CITY OF
West Linn
PLANNING AND DEVELOPMENT

**STAFF REPORT
PLANNING MANAGER DECISION**

DATE: August 6, 2015
FILE NO.: DR-15-09
REQUEST: Class I Design Review for Starbucks at 18900 Willamette Drive
PLANNER: Peter Spir, Associate Planner

SITE PLAN WILLAMETTE DRIVE STARBUCKS WEST LINN, OREGON		SHEET NO. 1 OF 1 JOB NO. MF-03
---	--	---

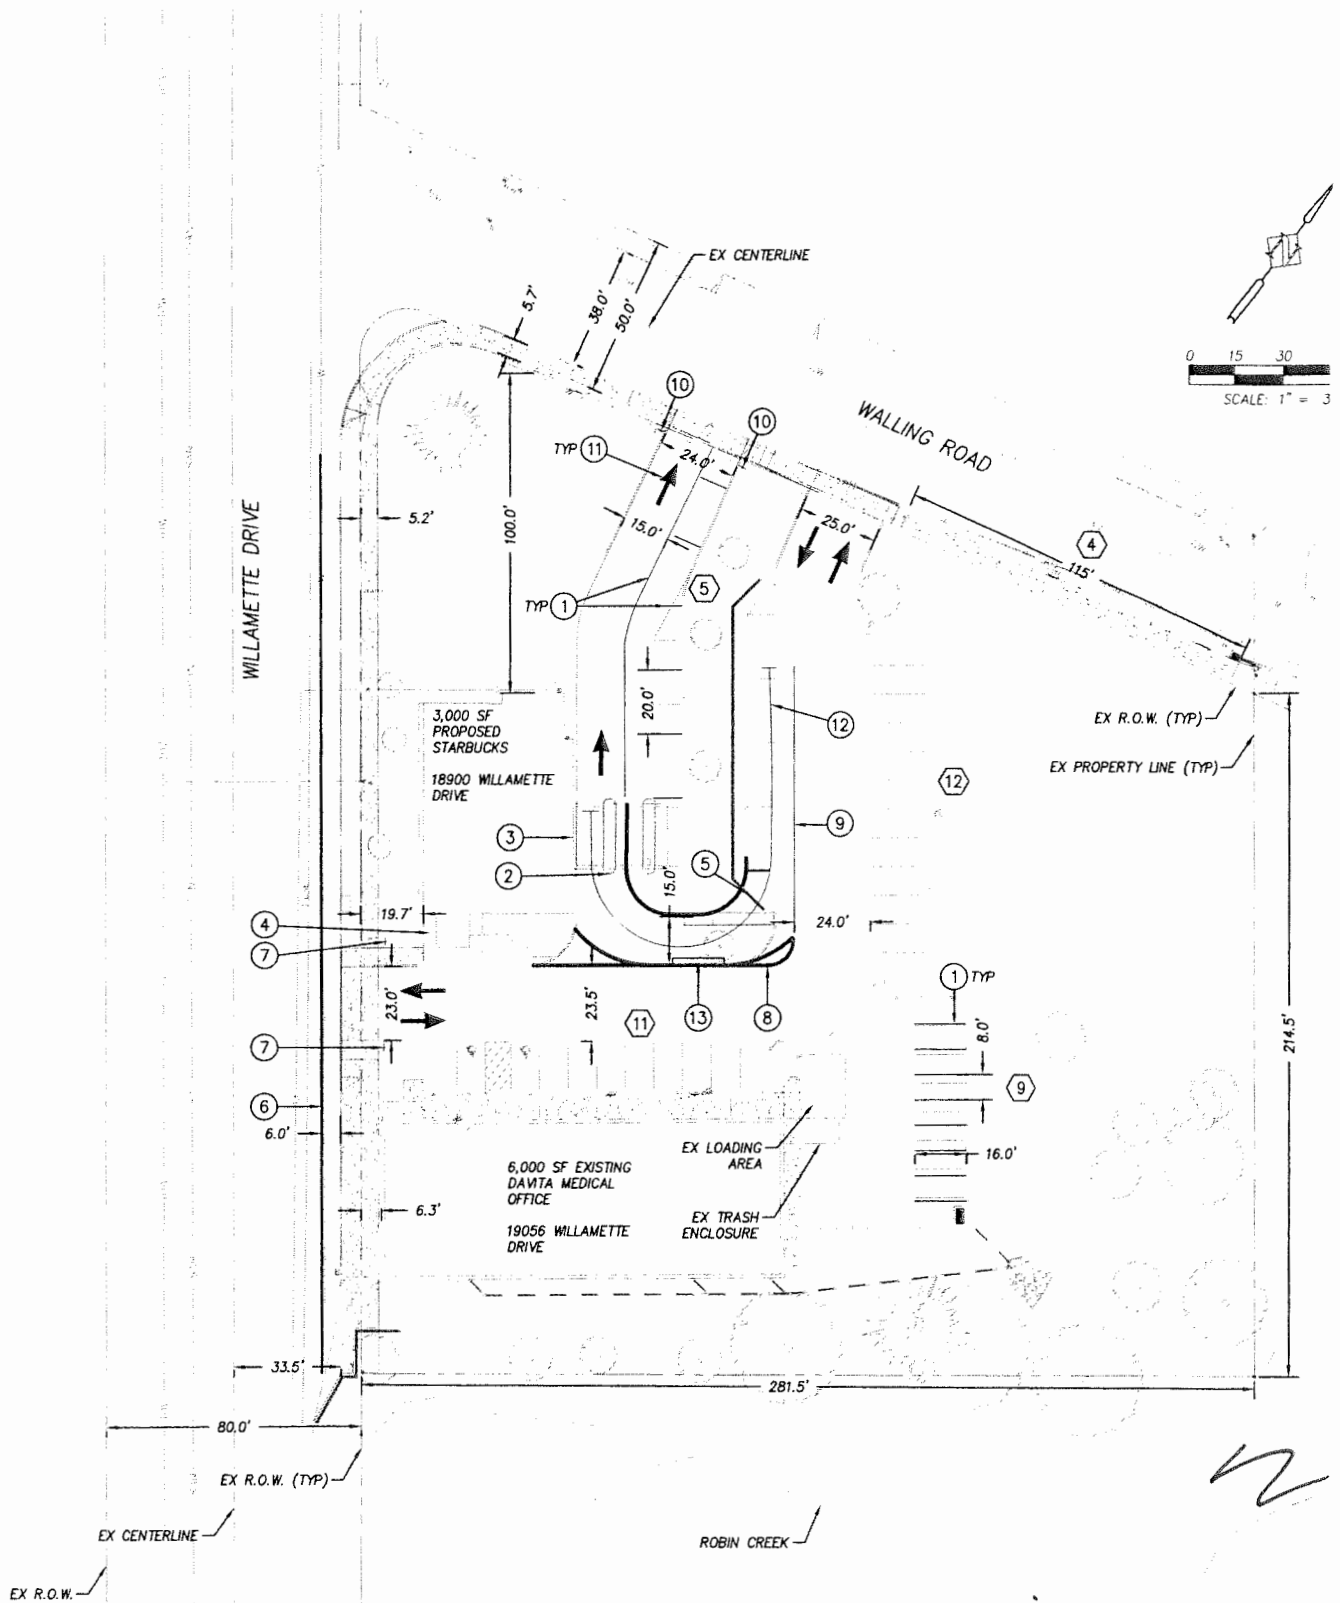
- **Inadequate pedestrian walkway through parking lot to the Bank of the West/Starbucks building. The proposed striped pathway is also only five feet wide when it should be six feet. The proposed painted pedestrian way puts pedestrians in potential conflict with two way driveway traffic and traffic backing out of spaces in front of the dialysis clinic. The pedestrian walkways should be distinct and provide some measure of security.**

This means that you should resubmit a plan deleting the hash marked pedestrian access in the driveway. Also show the relocation of the stacking/queueing driveway to the area where the four parking spaces were originally proposed. This would facilitate better circulation and backing up of parked cars (allow 23 foot back up space instead of 14" 6'). Those four spaces should be relocated to the area on Walling Drive east of the two way driveway. With these changes, only a class I Design Review (Planning Manager decision) would be required.

Response: The applicant has removed the striped crosswalk, moved the drive-thru lane farther west and identified on-street parking on Walling Road. The site now complies with the parking dimensional requirements and a variance is no longer required.
